*To:* Transport Infrastructure Planning Unit, Department for Transport  
*Subject:* Network Rail (Cambridge South Infrastructure Enhancements) Order  
*Date:* 3 August 2021 (with minor corrections and clarifications from 2 August version)  
*Contact:* Edward Leigh / 01223 312 377 / [edward@smartertransport.uk](mailto:edward@smartertransport.uk)  
42 Devonshire Rd, Cambridge, CB1 2BL

# Objection to TWA Order Application for Cambridge South station

Figure 1: Proposed design for station access junction with Francis Crick Avenue (from NR13 Deemed Planning Drawings)

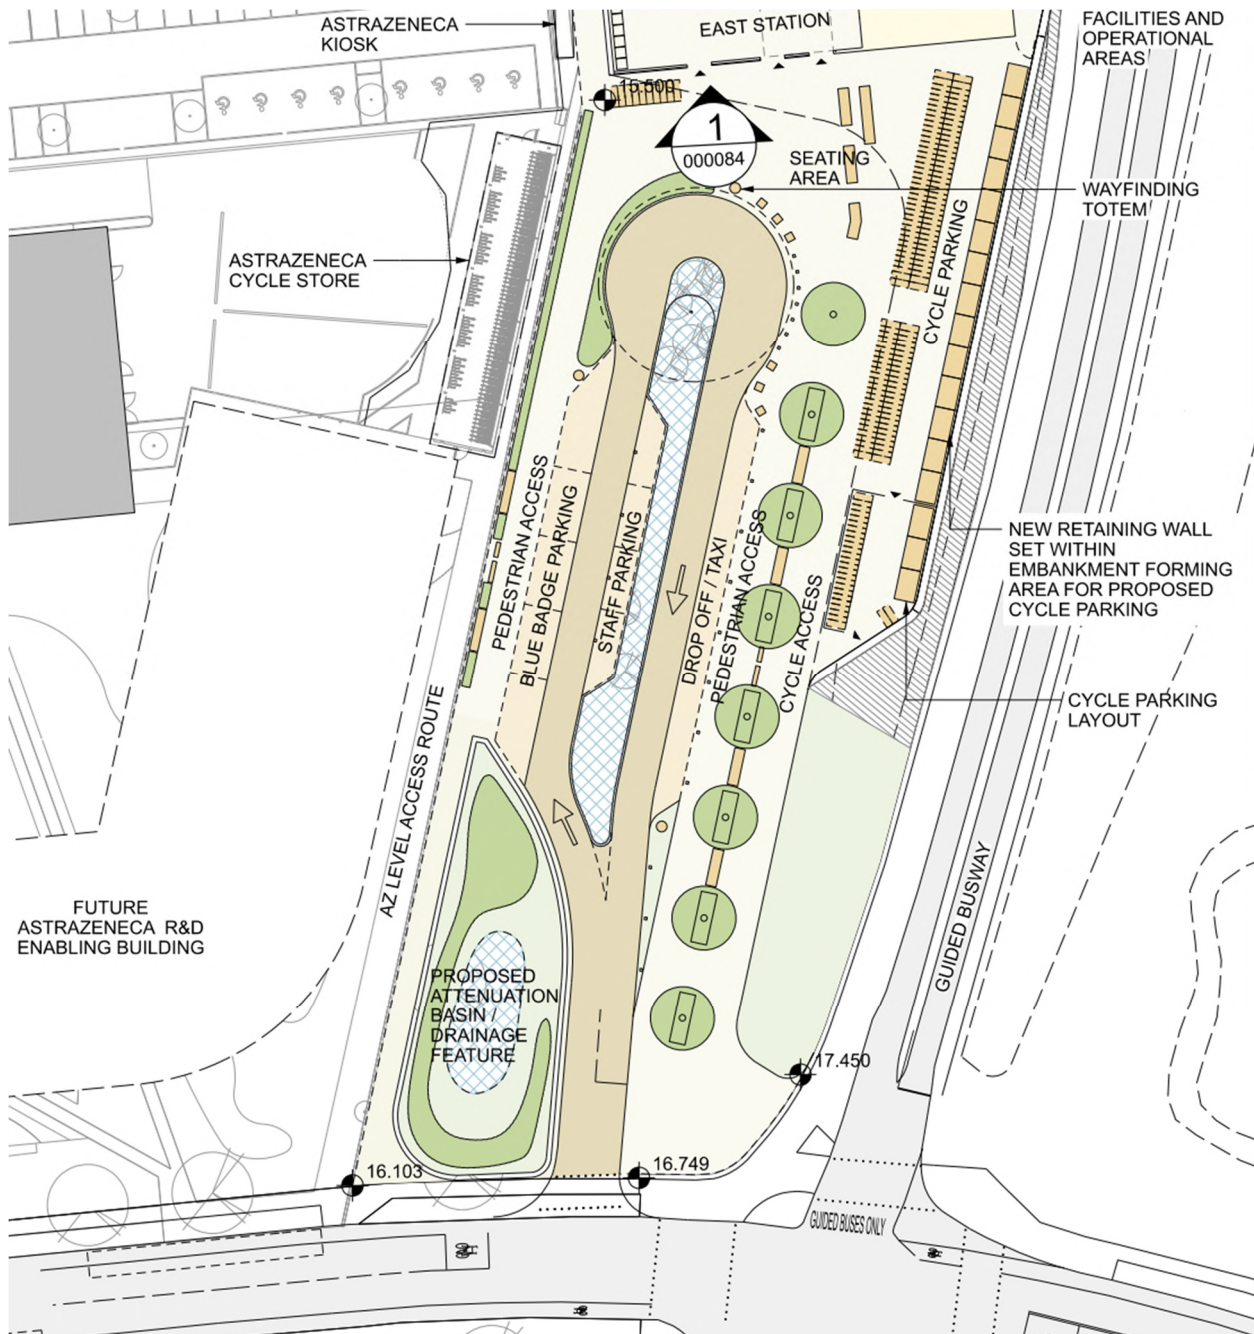
- TA §10.2.2 states, “three taxi bays are anticipated to provide sufficient capacity to meet average demand.” If the number of people using the station is underestimated then demand for taxis will also be underestimated. The pattern of taxi movements at Cambridge station is uneven, with a queue of taxis building up before the arrival of each train at peak times.

The number of private pick-up/drop-offs (which have use of another three bays) will also depend on the accuracy of forecasts for station usage and mode shares. The pattern of movements is also uneven.

Any underestimation in demand or significant deviations in demand from the average will lead to congestion on the access road (see Figure 1), potentially causing blocking back onto Francis Crick Avenue. It is unclear whether this has been modelled.

Figure 2: Diagram of busway junction with Francis Crick Avenue (from CSET plan dated 12 Feb 2021)

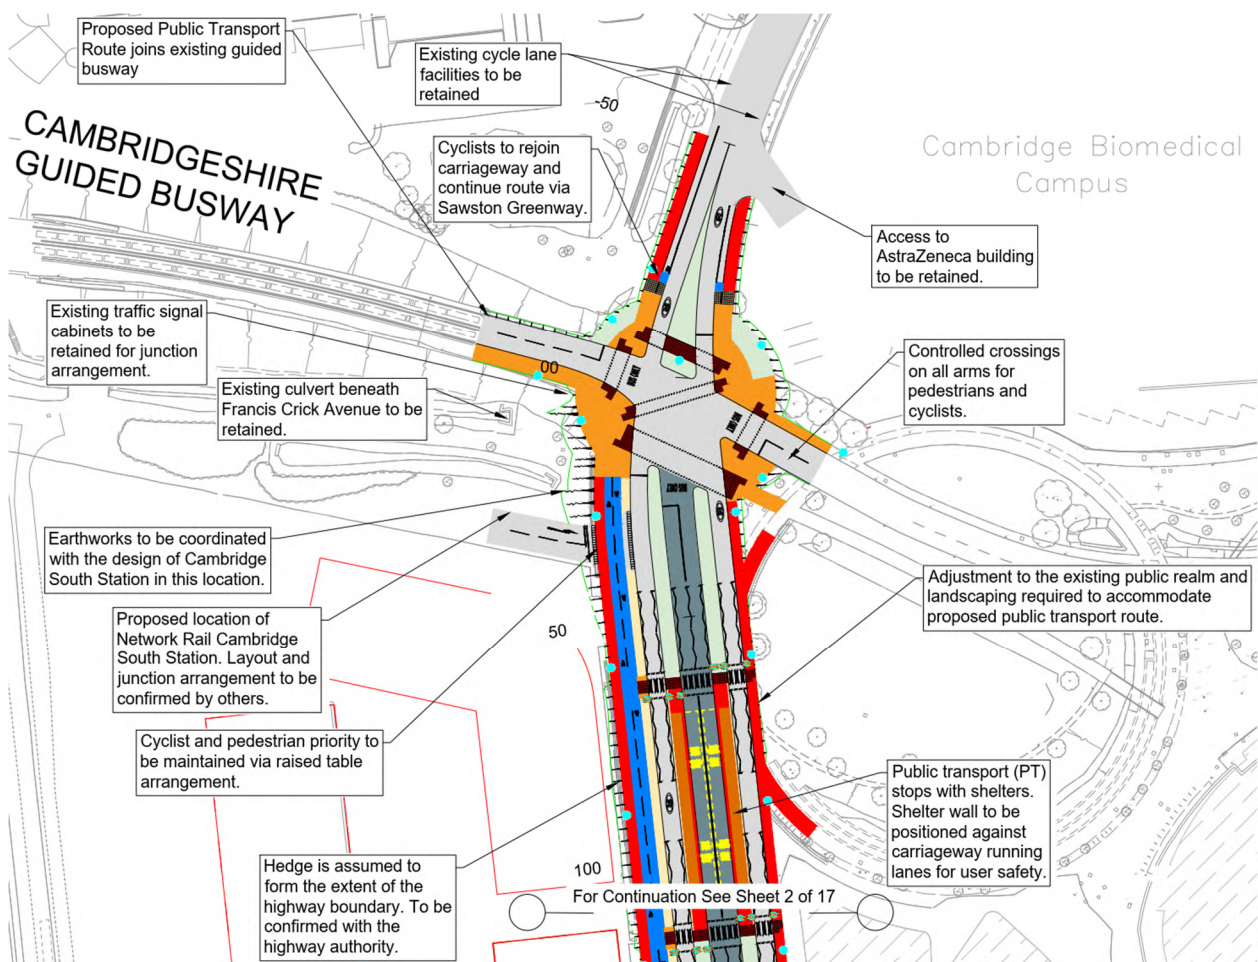
- TA §11.6.2 states that the bus stops *“are located to minimise passengers’ walking distances to and from ... the proposed station.”* This is patently untrue. The claim in the consultation report (NR07 p120) that *“the distance to Francis Crick Avenue is short and could safely be navigated by all user groups,”* is also debatable.

The bus stops on Francis Crick Avenue (see Figure 2) will be 200m from the station entrance. If alighting from the rearmost carriage of a 12-car train, the walk will be 450m (see Figure 3), taking 7 minutes at a typical walking pace of 4km/hour. The bus stops on the busway adjacent to Royal Papworth Hospital (which are not referred to in the application) are an additional 80m away. This does not accord with the government’s [Bus Back Better](#) guidance, which states, *“Railway stations should be hubs for connecting services with high quality stops close to station entrances”* (p32).

Figure 4: Schematic representation of alternative station configuration and access arrangements

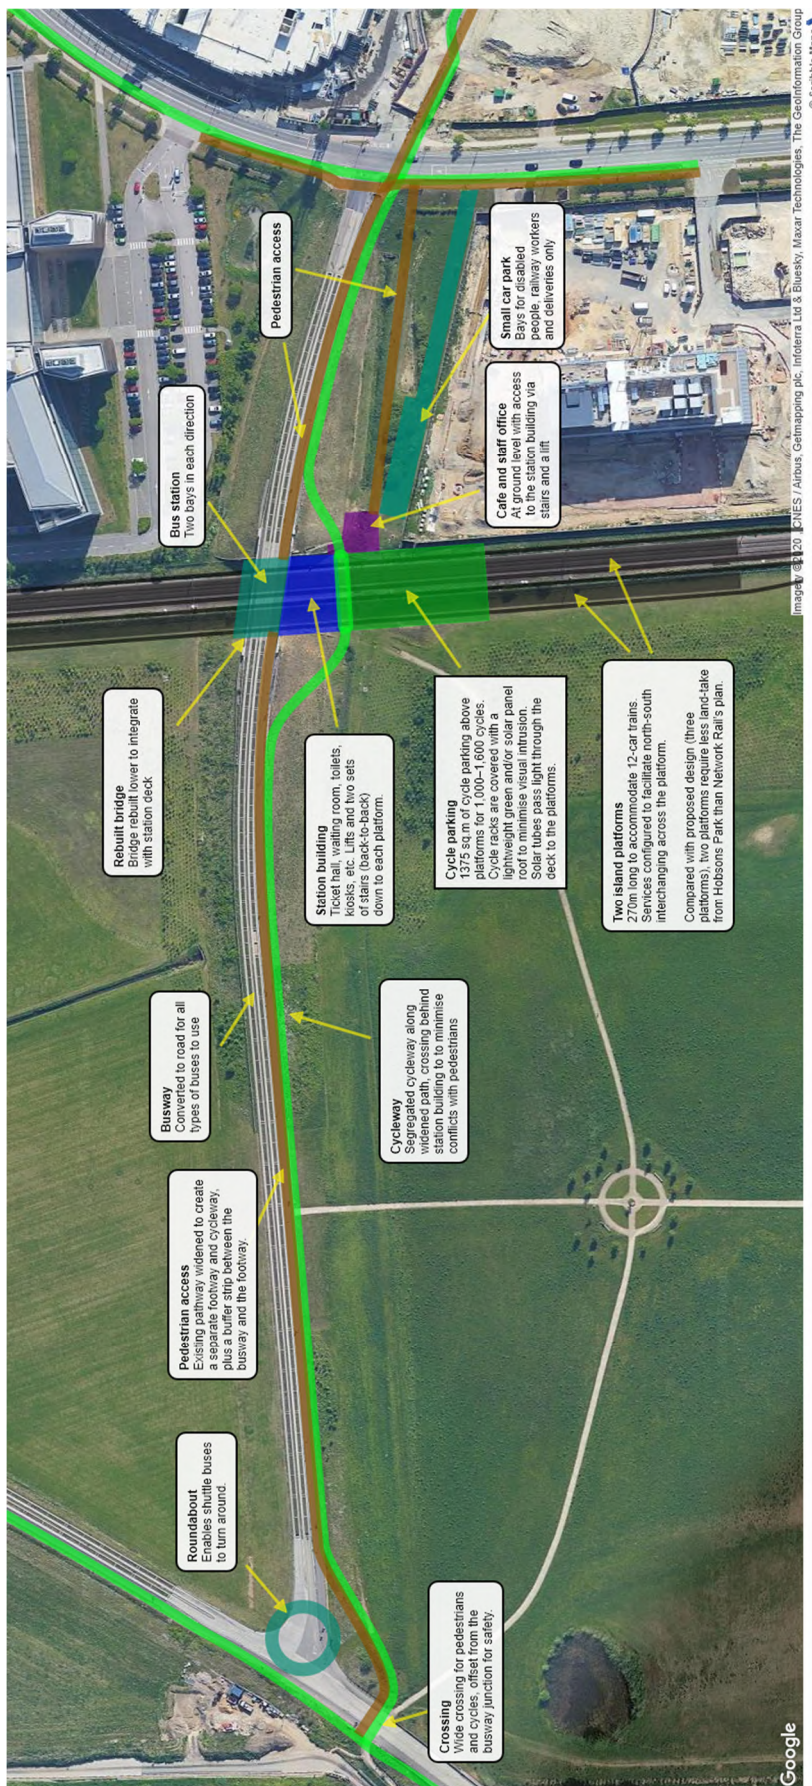
We recommend (see Figure 4):

- Build the station ticket hall above the tracks.
- Rebuild the busway bridge connected to, and at the same level as, the station.
- Include a bus station on top of the bridge immediately in front of the main station entrance.
- As part of rebuilding the bridge, widen the non-motorised user path, segregate it for pedestrians and cycles, and separate it from the busway by a buffer strip.
- Locate the cycle park behind (south of) the ticket hall with its own entrance to the station, and connected directly to the cycleway on each side of the bridge.
- Provide parking bays at ground level only for disabled people, railway workers and deliveries.
- Do not provide a taxi rank or private pick-up/drop-off area.

- It accommodates a much high flow of people into and out of the station, and onto and off the platforms.
- The walking distance between bus stops and the station entrance are under 20 metres.

- The furthest walking distance from one end of a 12- or 10-car train to the ticket hall would be half that of the proposed station design, or approximately 120 metres less.

Figure 5: Diversionary route for cycles and pedestrians while the busway bridge is closed. Buses would travel via the Addenbrooke's Rd–Hobson Ave roundabout.

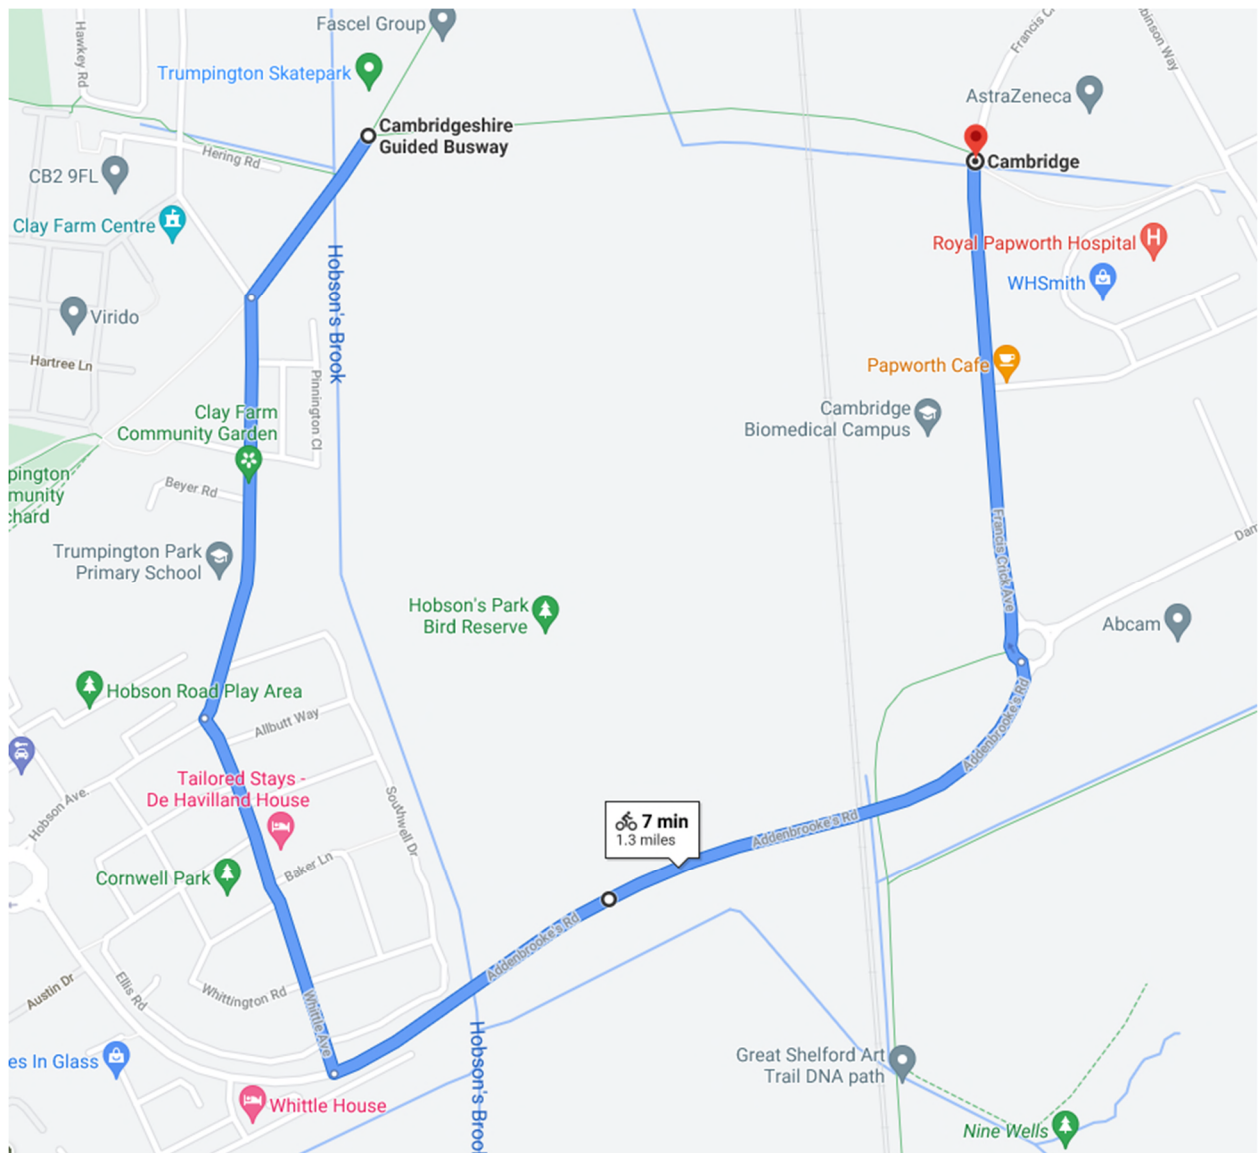
The additional cost would be more than offset by larger user benefits, derived from a realistic forecast of station users, plus quicker and more comfortable transfers between rail and bus. Disruption would be unavoidable, but a temporary bus and cycle diversion via Addenbrooke’s Rd and Hobson Ave and, for cycles and pedestrians, Whittle Ave (see Figure 5), would be feasible and not overly burdensome for a few weeks. The supposed complexity of maintenance and safety issues are not explained, and can almost certainly be overcome with an appropriate design and budget. Any concerns about the visual impact may be addressed through the use of sympathetic architecture and landscaping.
